## PUBLIC UTILITIES COMMISSION

**Re: Data Request #24 for the SDG&E Sunrise Powerlink Transmission Project,  
Application No. 06-08-010**

## Data Request 24

Map 1: Access road through Smith residence (house circled in blue)

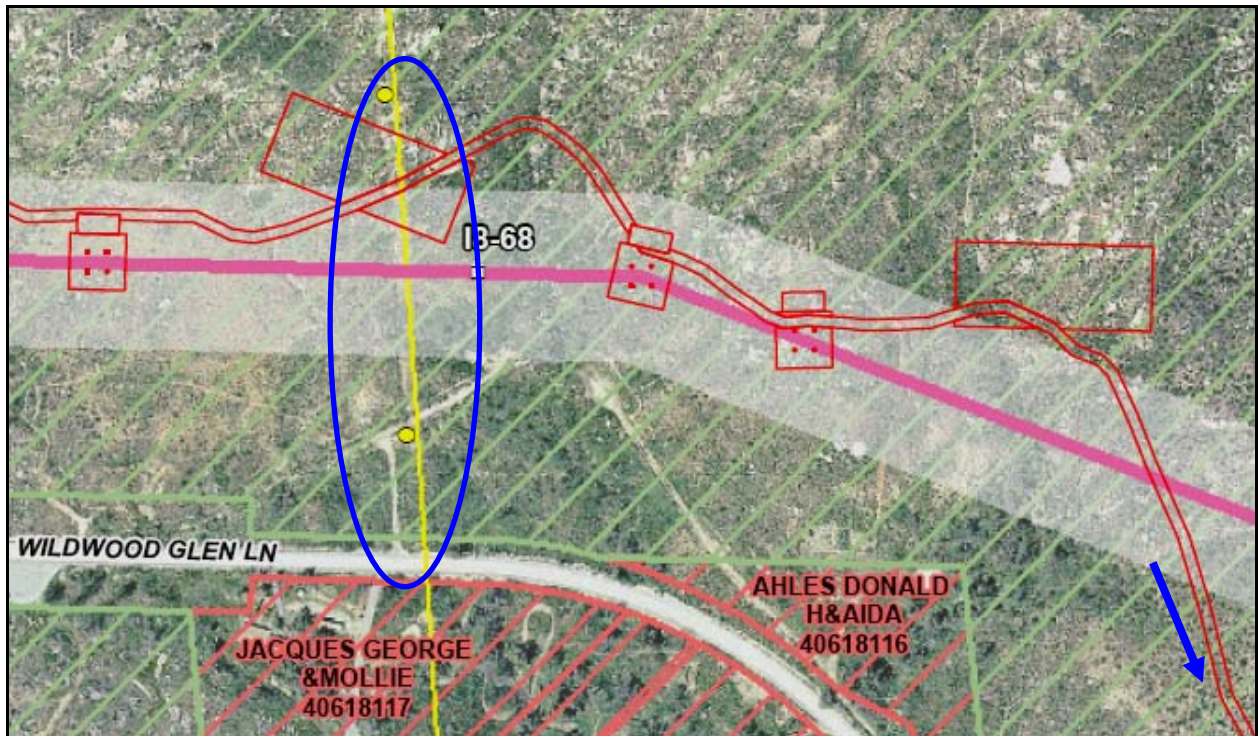
**d. Example 1.** Maps 1 through 3 on the following pages illustrate an example of a serious access road problem. Dr. Dave Smith lives along the Interstate 8 Alternative at 24414 Wildwood Glen Lane, Alpine. The photo in Map 1 illustrates a portion of a very long access road that would provide access to towers S3024 and S3023. The road goes directly through Dr. Smith's home. There are two problems with this situation. The first is that it makes no sense to design an access road through an existing residence. The second problem is that the long access road would serve a future tower that is located only a few hundred feet from the existing SDG&E 69 kV line leading to the Descanso Substation, which already has an access road.

Please explain the rationale behind the development of access roads in this area and in all areas of the project/alternatives. Describe the process that SDG&E would use to correct this situation if this route was approved and access roads were not modified in the Final EIR/EIS.

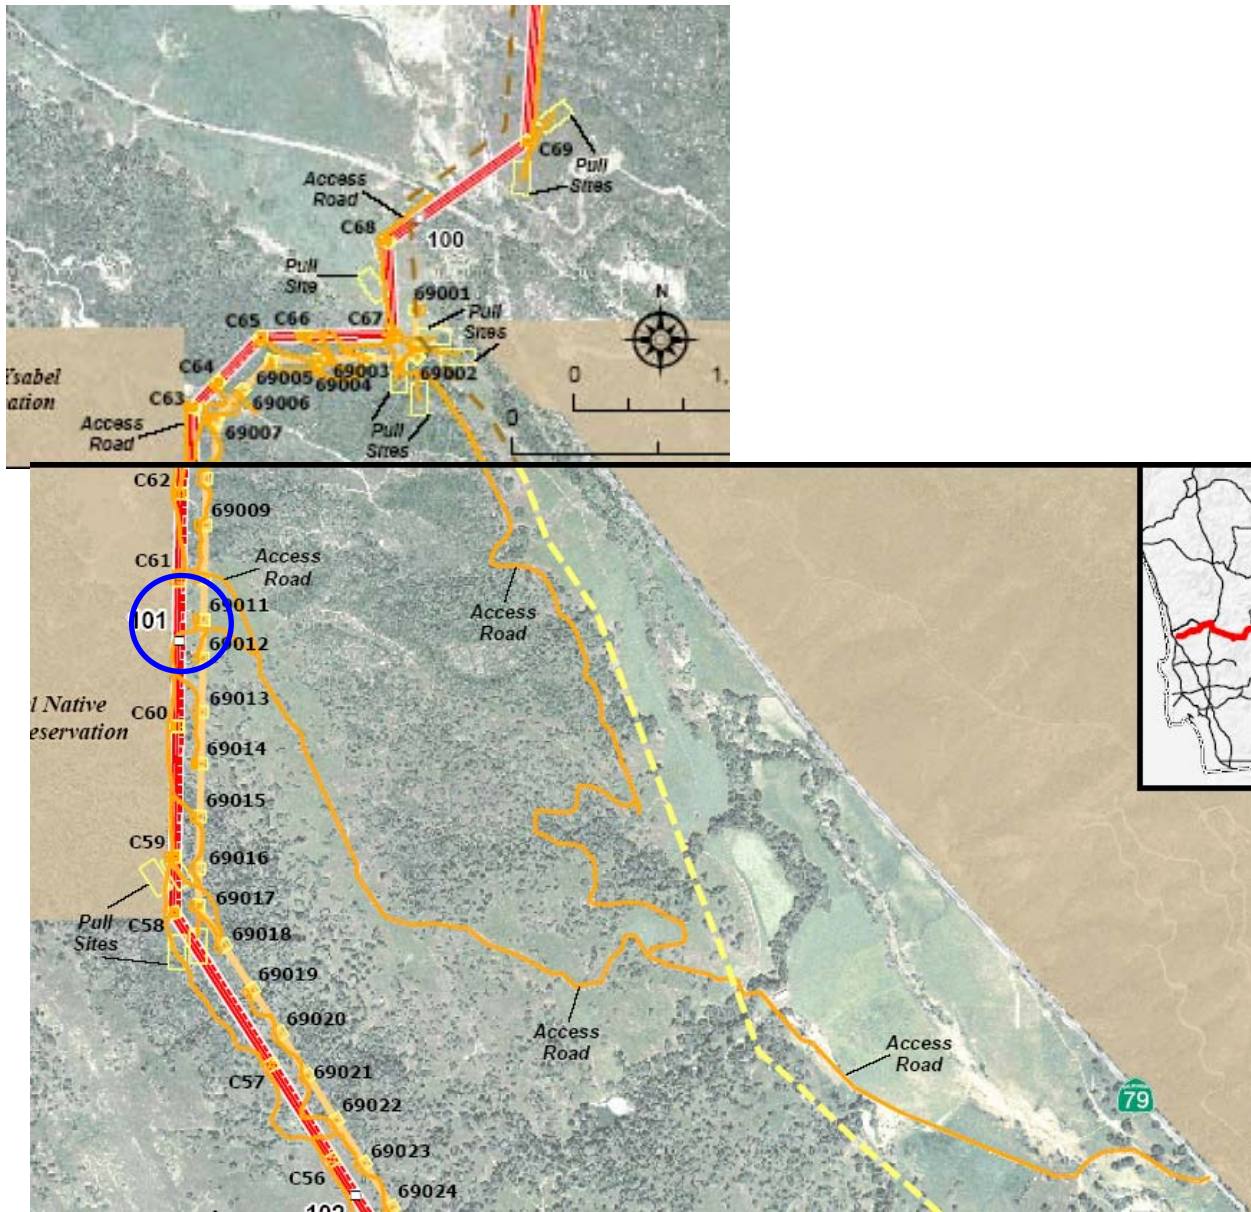
**e. Example 2.** Map 4 shows access roads (in gold) through Moretti property for Proposed Project access in northern Santa Ysabel Valley. The entire transmission corridor would be accessible using a new access road along the corridor itself, but additional access roads are shown in SDG&E's preliminary design, requiring very long access roads that meander through the entire Moretti property.

Please explain the rationale behind the development of these access roads, and whether SDG&E could construct and maintain the project using only the roads along the corridor itself. Also, if additional access to this route segment is required, describe in detail the process that would be

used to work with the landowner to select a route that minimizes impact to their land and operations.

**Map 5. Interstate 8 Alternative where it crosses the Interstate 8 Freeway in Imperial County. Purple dashed line is existing SWPL (400 feet from I8 Alternative). Access road shown in orange (adjacent to pink transmission line).**

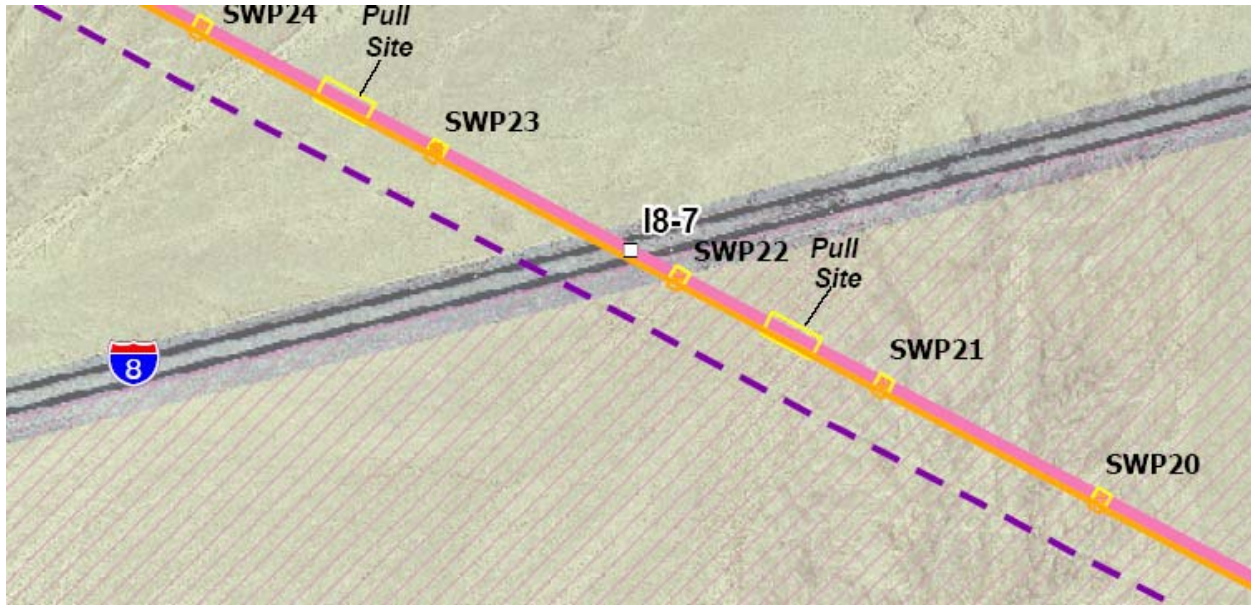
**f. Example 3.** Maps 5 and 6 show segments of the Interstate 8 Alternative where it parallels the existing Southwest Powerlink transmission line. One of the benefits of collocating a new transmission line with an existing line is that the existing access road can generally serve both lines. In most topography, only spur roads from the existing road to the proposed new tower would be required.

Explain why SDG&E has shown a new access road along the collocated portion of the Interstate 8 Alternative, rather than assuming use of the existing SWPL access road.

Of the “143 miles of access roads” required for the Interstate 8 Alternative (from SDG&E testimony), how many miles are either already existing access roads for the SWPL, or could be eliminated by using SWPL access roads?
